**F KOLKATA PORT TRUST**

**HALDIA DOCK COMPLEX**

**Tender No.: SDM (P&E)/T/34/2018-19**

**♠ ADDENDUM-V ♠**

**TITLE:**  
**SINGLE LINE DIAGRAM FOR JETTY FIRE FIGHTING SYSTEM**  
**AT HALDIA DOCK COMPLEX**

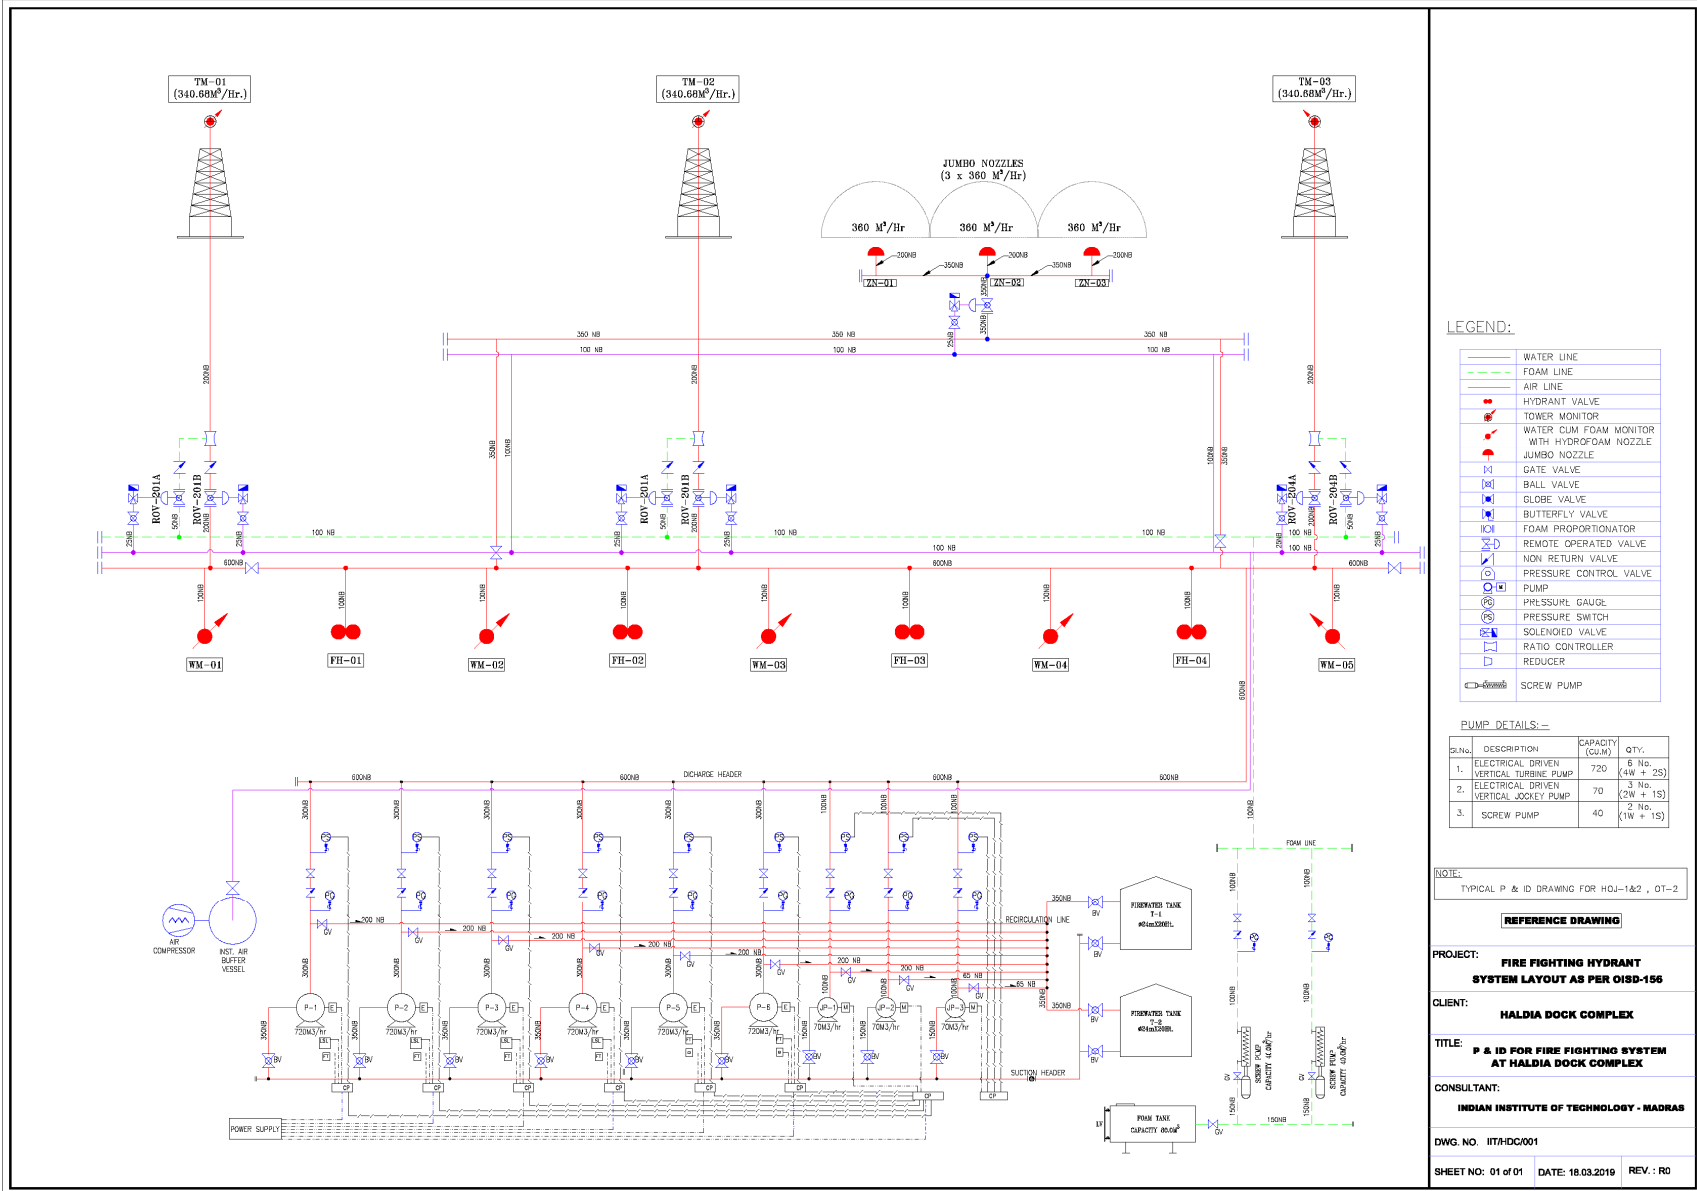
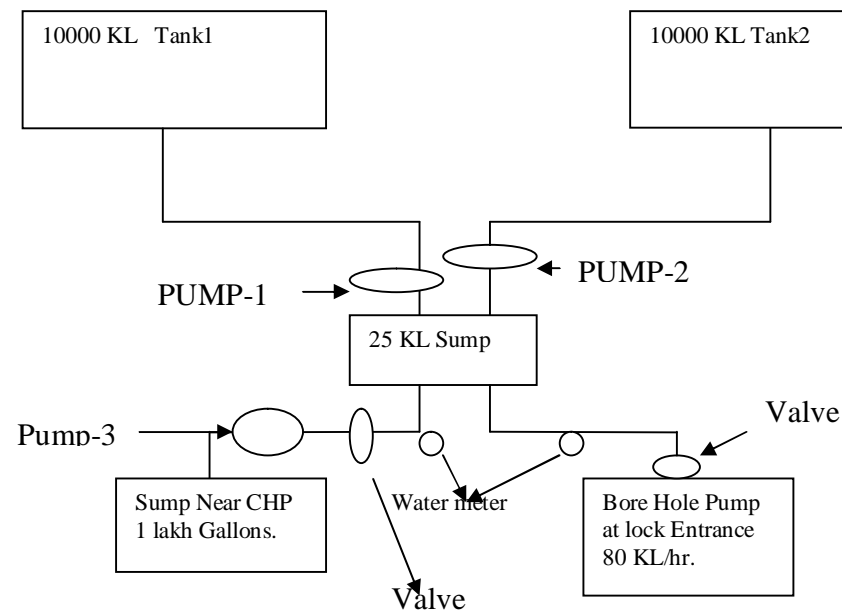
3	Sl. No: 17 Addendum-III Page 9	Please find our letter as annexure-1 for payment terms. Request you to kindly accept the terms mentioned in Annexure-1.	The prevailing payment terms will remain unchanged.
4	Sl. No: 25 Addendum-III Page 17	SLD provided at page 35 of addendum-III is not legible. Please provide the legible copy of same.	The SLD provided is only for the format purpose. Tentative. SLD is attached as <b>Annexure-B</b> . The bidder should develop on his SLD to suit as per present requirements.
5	Sl. No: 29 Addendum-III Page 17	SLD provided at page 37 of Addendum-III is not legible. Please provide the legible copy of same.	It is a tentative SCADA system layout drawing. Tentative drawing of Scada System is attached as <b>Annexure-C</b> . Same has to be developed by bidder as per present requirements

<b>25</b>	Annexure – III,	Breakup of tentative items, B - Procurement shows Quick Release Mooring Hooks – 8 No's, please confirm the capacity of each hook and area of installation. (We understand that these hooks are for new OT – II terminal), Please clarify.	Each Hook should carry 25 Tons and THREE HOOK configuration with four nos. in HOJ-1 another four in HOJ-2
<b>26</b>	Annexure – IV	SLD of Electrical system is not visible clearly, kindly provide us the clear SLD diagram.	The SLD is only for the format purpose. Please refer Sl. No.4 above. The bidder should develop on his own SLD as per

present requirements.
<b>27</b>	Annexure – V	P& ID of Fire Fighting system is not visible clearly, kindly provide us the clear P& ID diagram.	Reference P & ID Attached. Please refer Annxeure-D.
<b>28</b>	Annexure – VI	SLD communication system is not visible clearly, kindly provide us the clear SLD communication system diagram.	It is not SLD, it is a tentative SCADA SYSTEM LAYOUT drawing. Please refer SI.no. 5 above. Same has to be developed by bidder as per present requirements
<b>29</b>	Annexure – VII, Volume – II of section I	It is specified that HOJ – I & II jetties shall be provided with illumination on jetty, approach area, escape route etc., on old structures. However, it is understood that all these structures at HOJ – I & II are already been illuminated. Request you to kindly clarify the same as it is confusing	Replacement of existing lighting arrangement with new one (flame proof fittings with accessories including FRLS cables, switch gear etc.) is under the scope of the contractor. Illumination shall be maintained by contractor as per Dock safety rules in HOJ-I,HOJ-II,OT-II and Barge Jetty 1 & II.
